Takes of Marine Mammals Incidental to Specified Activities; Marine Geophysical Survey in the Northwest Atlantic Ocean offshore North Carolina, September to October, 2014

ACTION: Notice; issuance of an incidental harassment authorization.

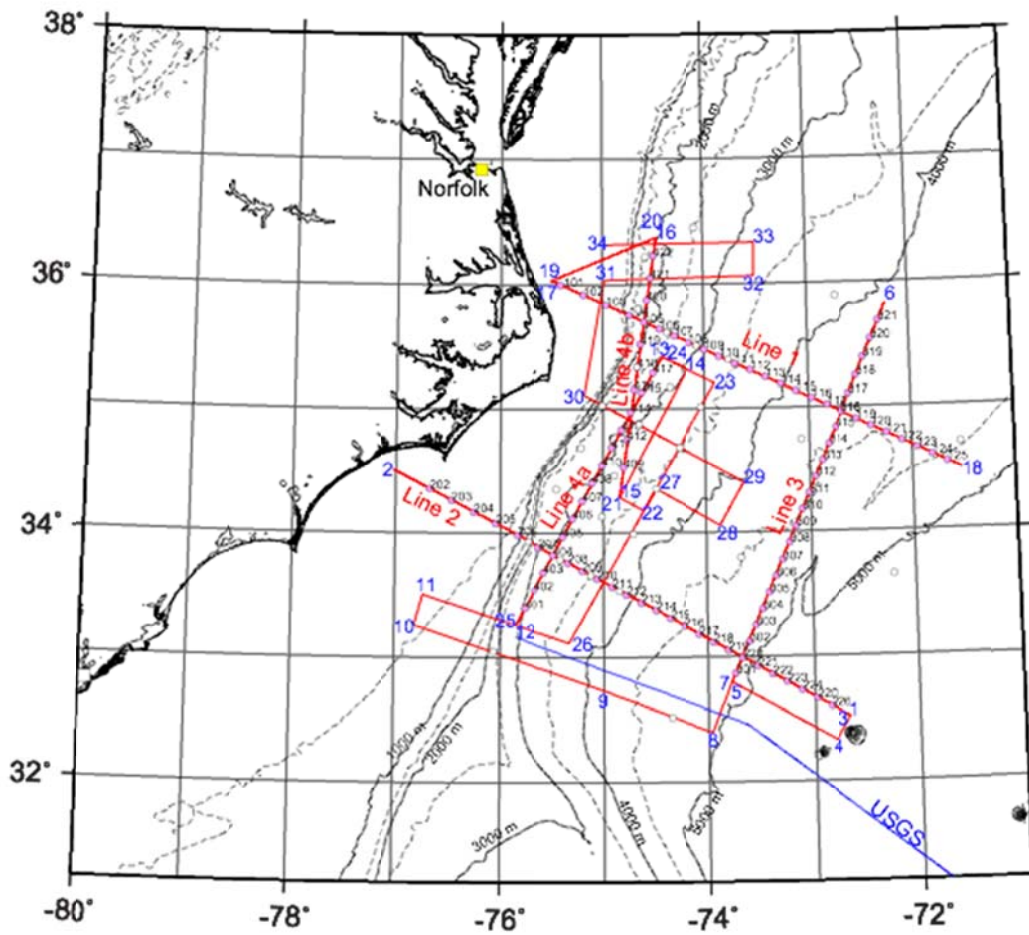
Comment 14: The Commission understands the Lamont-Doherty would survey the OBS tracklines twice, once for acquiring OBS data and once for recording source shots with the MCS. Because Lamont-Doherty did not estimate the ensonified area based on repeating the OBS tracklines, the Commission recommends that we require Lamont-Doherty to re-estimate the total numbers of takes based on surveying the OBS portion two times and base our “small numbers” and “negligible impact” determinations on those revised take estimates.

Comment 15: NRDC et al. states that Lamont-Doherty provides no justification for the particular trackline configuration (see Addendum) and why that design elected to remove the 25 percent contingency that it typically adds to its tracklines, as opposed to other potential designs

Response: Lamont-Doherty modeled the number of individuals that could be exposed to airgun sounds with received levels greater than or equal to 160 dB re: 1  $\mu$ Pa on one or more occasions by multiplying the total marine area that would be within the 160-dB radius around the operating seismic source on at least one occasion (40,968 km<sup>2</sup>) along with the expected density of animals in the area. However, as the Commission noted, this approach does not account for Lamont-Doherty acquiring data for the ocean bottom seismometer (OBS) portion of the survey tracklines which includes two instances of ensonification (i.e., one pass for acquiring OBS data and a second pass for recording source shots with the multi-channel seismic (MCS). On average, for a 400-km line segment, the Langseth traveling at 8.3 km /hour would take approximately 4 days to complete the acquisition. In total, there are 10 tracklines that would require repeat coverage (see Figure 1 in this notice, Lines 1 through 4b).

We have revised the take estimates to account for the 10 tracklines that would require repeat coverage. The Authorization accounts for the modified number of tracklines (including repeated tracklines) shown in Figure 1 in this notice. We note that unlike previous seismic surveys aboard the Langseth, Lamont-Doherty would conduct the 2-D survey as almost one continuous line. Therefore, the ensonified area for the seismic survey does not include a contingency factor (typically increased by 25 percent to accommodate turns and equipment testing, etc.) in line-kilometers. Also, any marine mammal sightings within or near the designated exclusion zones will result in a power-down and/or shut-down of seismic operations as a mitigation measure effecting the least practicable adverse impact on marine mammals.
